CNL-15-073

September 16, 2015

Browns Ferry Nuclear Plant, Units 1, 2, and 3  
Renewed Facility Operating License Nos. DPR-33, DPR-52, and DPR-68  
NRC Docket Nos. 50-259, 50-260, and 50-296

Subject: **Application to Modify the Browns Ferry Nuclear Plant, Units 1, and 2 Technical Specifications by Adding New Specification TS 3.3.8.3, "Emergency Core Cooling System Preferred Pump Logic, Common Accident Signal (CAS) Logic, and Unit Priority Re-Trip Logic," and Unit 3 TS by adding New Specification TS 3.3.8.3, "Common Accident Signal (CAS) Logic, and Unit Priority Re-Trip Logic," (BFN-TS-486)**

D.1

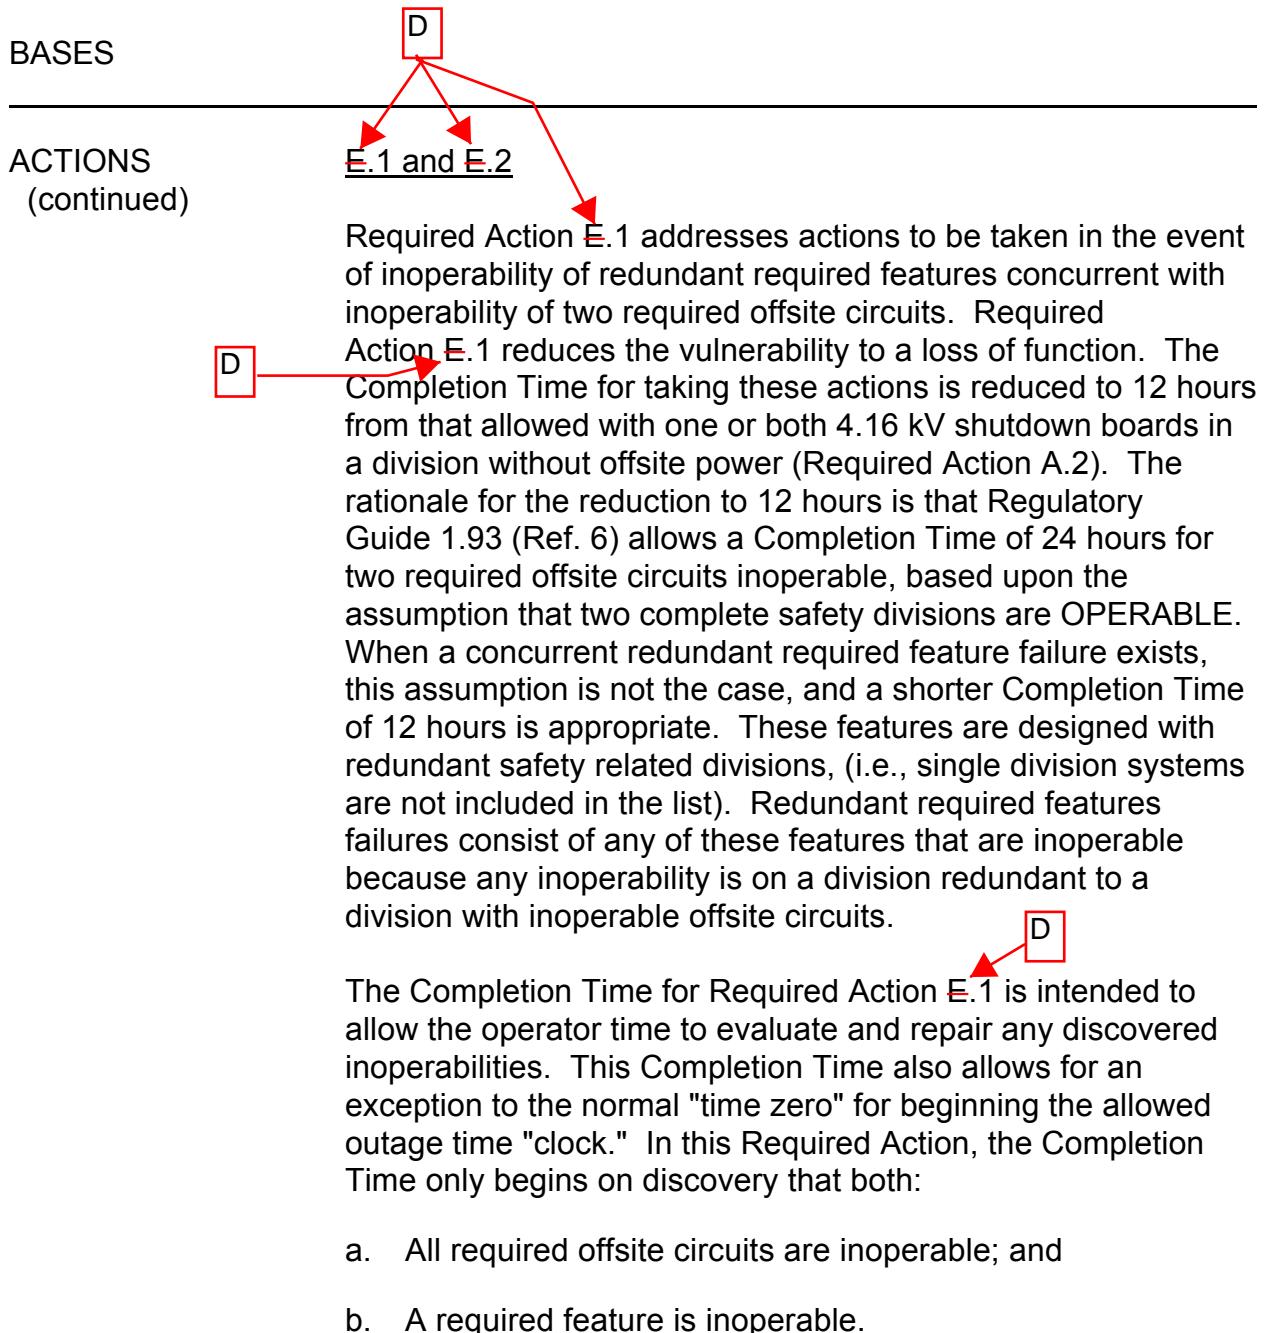
~~With one division of common accident signal logic inoperable (including the DG breaker unit priority re-trip function and the CS and LPCI preferred pump logic function described in Bases Section B 3.8.1), the plant electrical system response is degraded, and the potential for inappropriate electrical system alignment is increased with attendant potential challenge to plant safety systems. In this condition, however, the remaining division of common accident signal logic is capable of performing its intended function of providing a start signal to the Unit 1 and 2 DGs during a DBA.~~
